**GOVERNMENT OF THE DISTRICT OF COLUMBIA
DEPARTMENT OF TRANSPORTATION**

MEMORANDUM

SUBJECT: **DDOT Report for BZA Case 18531, Heritage Foundation, Maryland Avenue, NE**

Figure 1: Proposed Site Layout and Access.

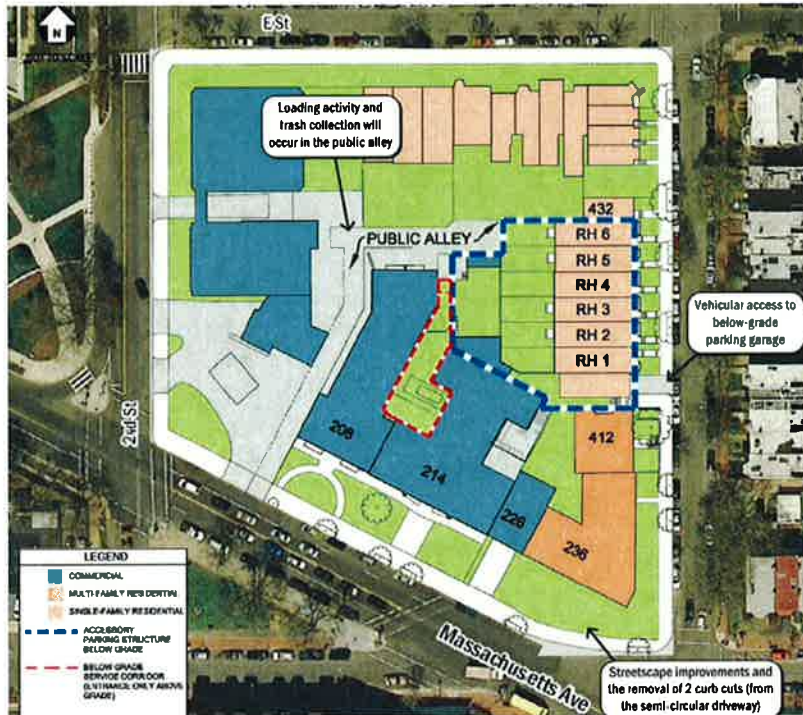
As shown in Figure 1, the Applicant is proposing a parking garage, accessible from 3rd Street, NE. The parking garage will serve vehicles for the six row houses along with commercial/office portion of the project, directly associated with the Applicant's activities. The parking garage will serve vehicle parking and long-term bicycle parking for commuters. The parking garage driveway is proposed to be full access. Pedestrian access to the Heritage Foundation and its accessory buildings is via Massachusetts Avenue. Loading and all trash collection is proposed from a 10' public alley, directly west of 208 Massachusetts Avenue. Trash collection associated with row houses will be through the parking garage to the public alley behind 208 Massachusetts Avenue.

Finally, 236 Massachusetts Avenue currently has two curb cuts that serve a circular driveway. The Applicant is proposing to eliminate these access points as part of its landscaping plan. DDOT supports the closing of this circular driveway as it eliminates two vehicle conflict points in a heavily pedestrian-traveled area.
